**TRANSMITTAL
LETTER**

**Publication 72M
April 2004 Edition
Change No. 2**

Revisions to Standards for Roadway Construction RCs 23M and 24M

BRIDGE APPROACH SLABS

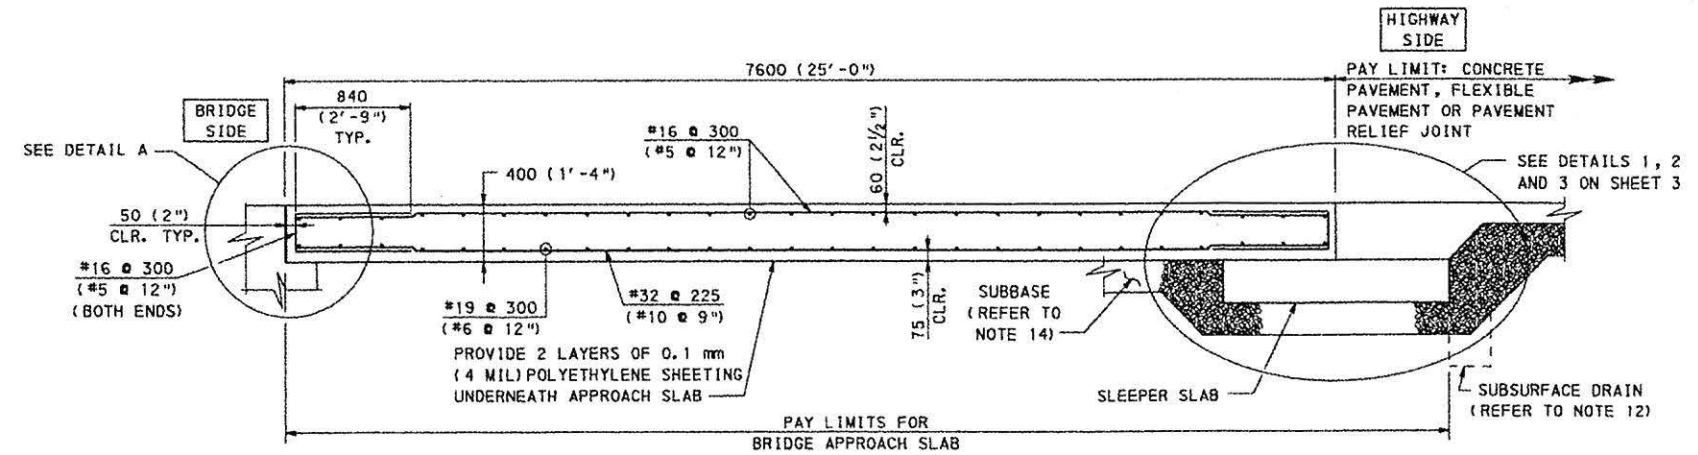
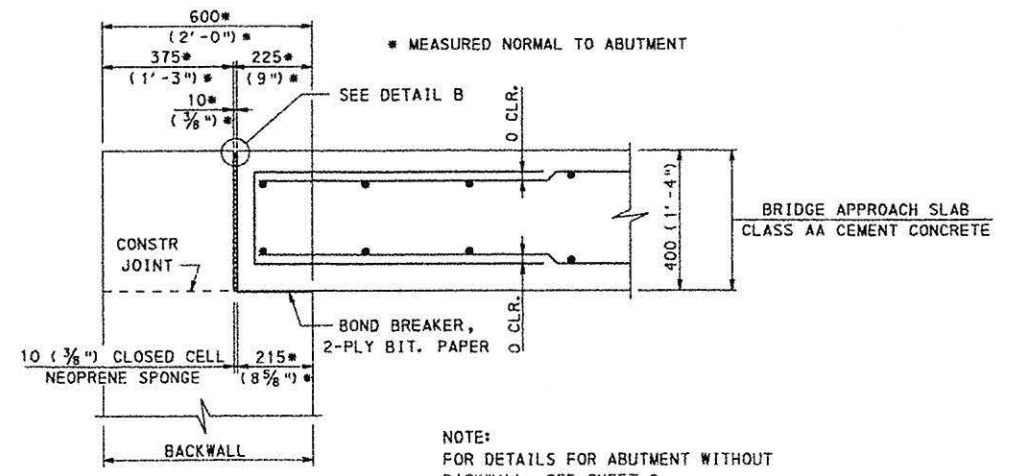
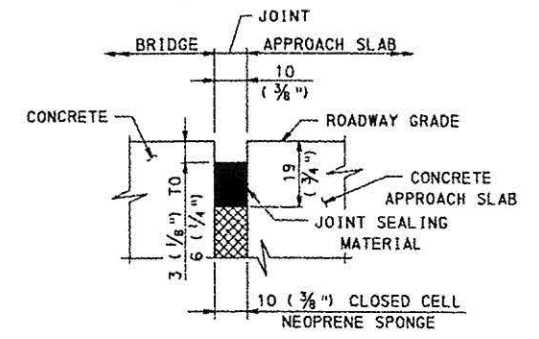
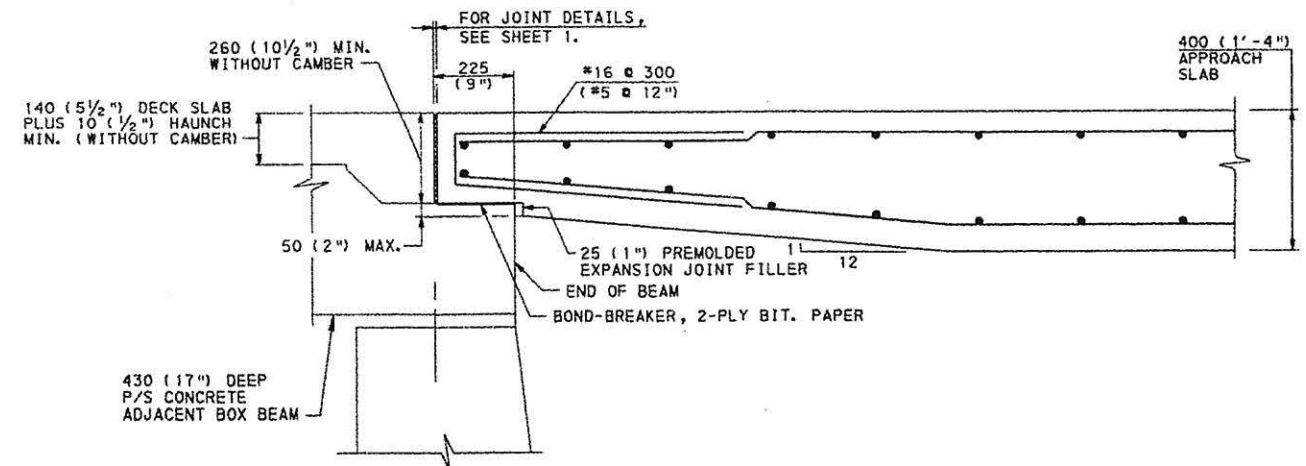
<u>STANDARD</u>	<u>SHEET</u>	<u>DESCRIPTION OF CHANGES</u>
Index	1 of 1	RC-23M – revised date. RC-24M – revised number of sheets and date.
RC-23M	All Sheets	Standard revised. Details revised to agree with BD-628M and RC-24M. Integral Abutment Approach Slab details eliminated and moved to BD-628M.
RC-24M	All Sheets	Standard revised. Details revised to agree with BD-628M and RC-23M.
